Access Compliance Report

Public Rights-of-Way

| Intersection ID: 5200 | Main Street: MT_HOLLY-HUNTERSVILLE_RD | Cross Street: NORTHWOODS_FOREST_DR | Location: NW |
| ADA ID: 96D8AE5DF810 | Ramp Type: BlendTrans1 | Initial Pass/Fail: Fail | Overall Compliance: No |

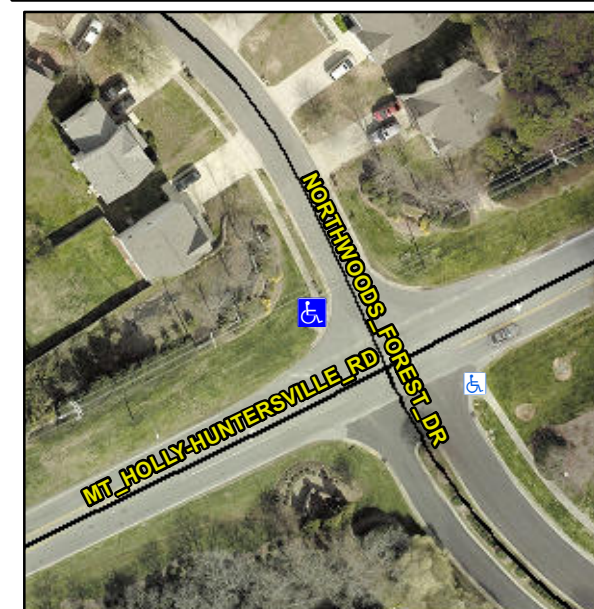
Not Found, R304.5.1, R304.5.3

| Compliance | Description | Data | Compliance | Description | Data |
|------------|-----------------------|------|------------|-----------------------------|------|
| No | Ramp Width (in) | 40.5 | No | BlendTrans XSlope (%) | 6.7 |

Remove & Replace Curb Ramp With Two New Directional Ramps or Equivalent.
